**Informal Document No. GRSG-94-26  
(94<sup>th</sup> GRSG, 21-25 April 2008,  
agenda item 3 (a))**

**PROPOSAL FOR DRAFT AMENDMENT REGULATION No. 107  
(M2 and M3 vehicles)**

Transmitted by the Expert from Spain

FIGURE 1.1

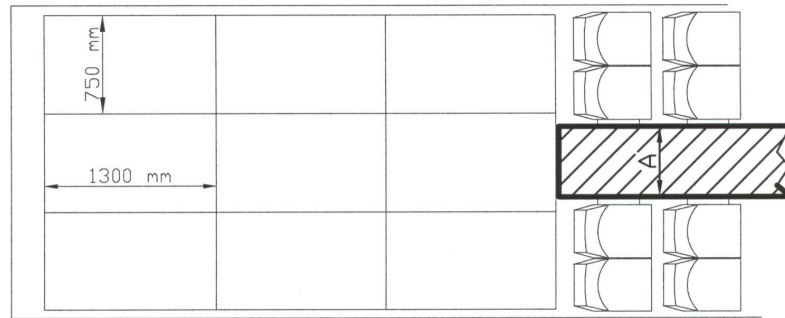
- 2.15. 'gangway' means the space providing access by passengers from any seat or row of seats **or each special area for wheelchair users** to any other seat or row of seats **or each special area for wheelchair users** or to any access passage from or to any service door or intercommunication staircase and any area for standing passengers; it does not include:

1- To guarantee the appropriate access to all passengers or crew members to each wheelchair user's specific areas, in order to, for example, give special cares or attention, helping with the wheelchair anchorage system, etc. (See figure 1 attached)

FIGURE 1.2

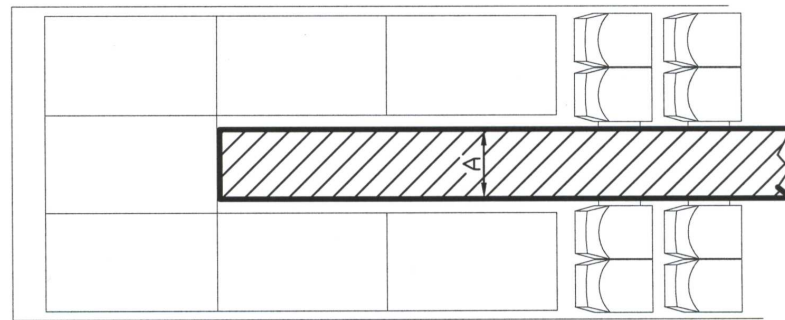
A: Diameter of lower cylinder (see point 7.7.5.1. Annex 3)
